**BOARD ACTION REPORT – APPEALABLE ITEM**

**Project Name:** Delray Ford  
**Project Location:** 2501 South Federal Highway  
**Request:** Class V Site Plan, Landscape Plan, and Architectural Elevations.

STAFF REPORT

AGENDA ITEM: Delray Ford (File #2017-034) – Class V Site Plan, Landscape Plan and Architectural Elevations associated with the construction of a 50,662 square foot automobile dealership at 2501 Federal Highway.

LANDSCAPE PLAN  
**DELRAY BEACH FORD**  
2501 SOUTH FEDERAL HIGHWAY  
DELRAY BEACH, FLORIDA 33483

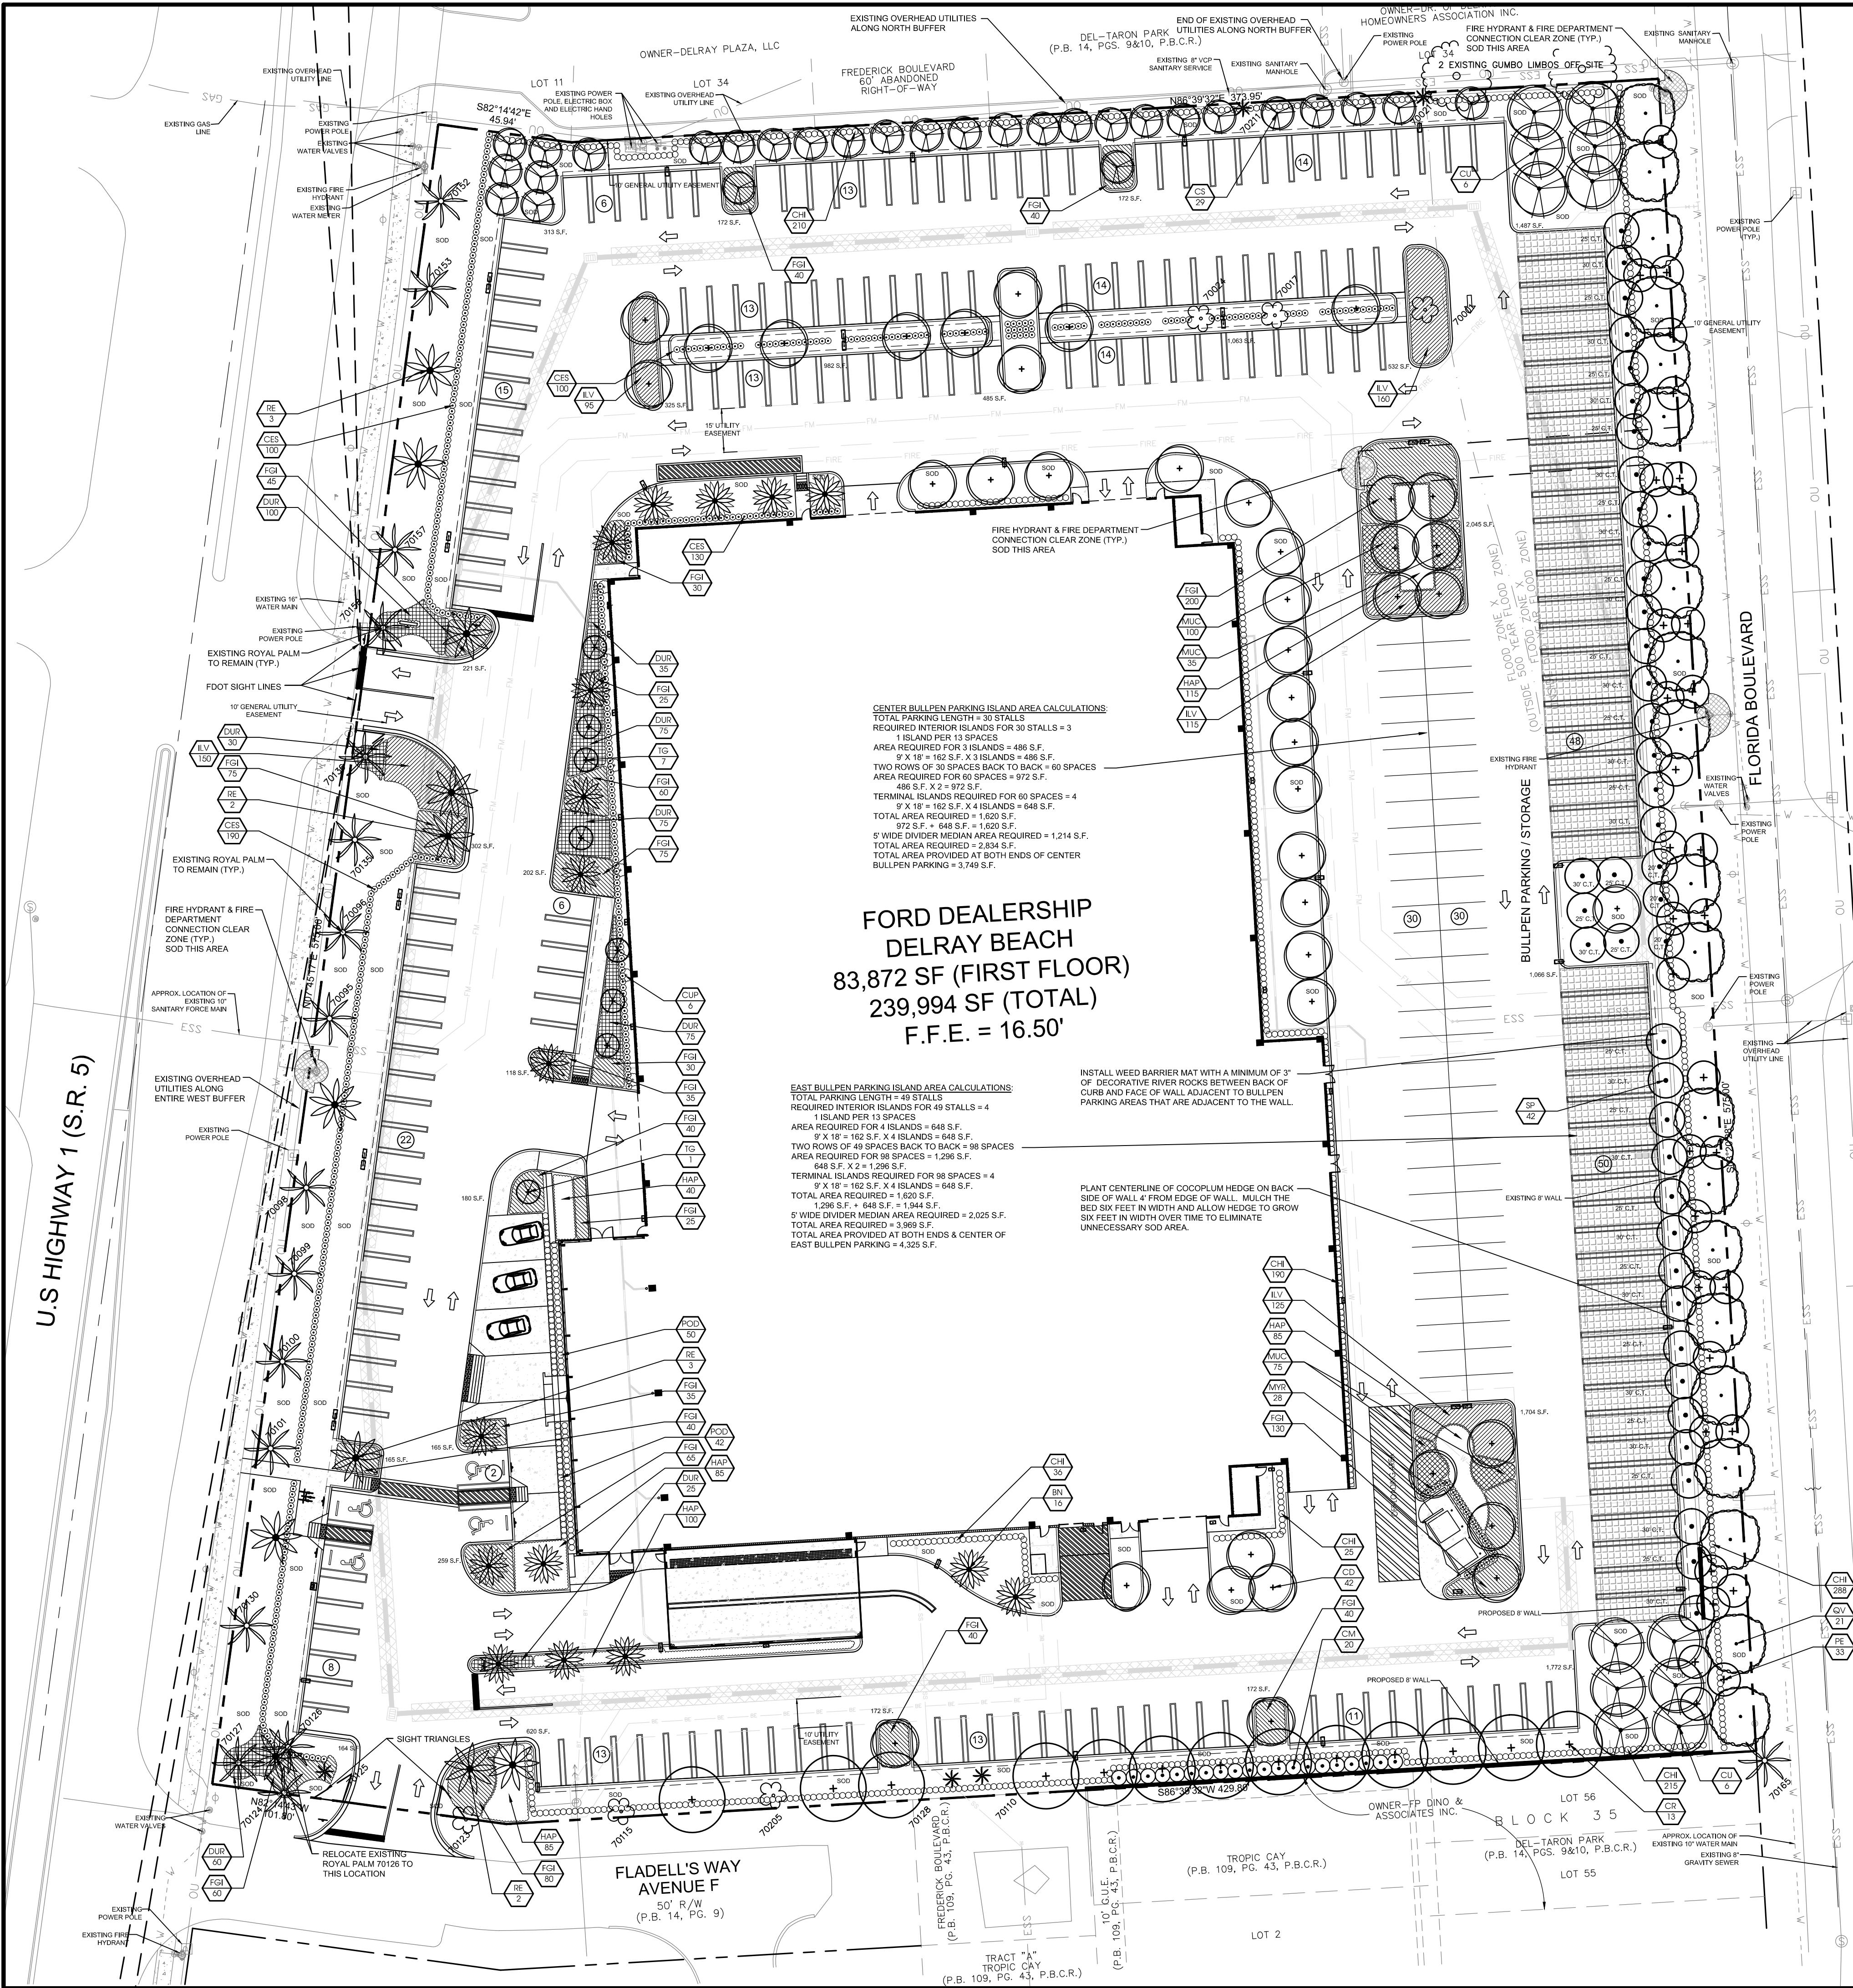
**Landscape Islands:** Per LDR Section 4.6.16(H)(3)(i), landscape islands which contain a minimum of 135 square feet of planting area, with a minimum dimension of 9 feet, exclusive of the required curb, shall be placed at intervals of no less than one landscaped island for every 13 standard parking spaces. One shade tree shall be planted in every island with a minimum of 75 square feet of shrubs and groundcovers. Tree specifications shall adhere to those listed in Section 4.6.16(E)(5) and 4.6.16(E)(6). Where approval for the use of compact parking has been approved, islands may be placed at intervals of no less than one 1 island for every 15 compact parking spaces. This landscape island is required for the display parking spaces along Federal Highway, where 22 and 15 parking spaces are provided in a row without the required landscape island. A condition of approval is attached that the plans be revised to provide the required interval of landscape islands and landscaping.

Approve the Landscape Plan for Delray Ford located at 2501 South Federal Highway, based on positive findings with respect to Section 4.6.16 of the Land Development Regulations, subject to the condition that the plans be revised to provide the required interval of landscape islands and landscaping along Federal Highway.
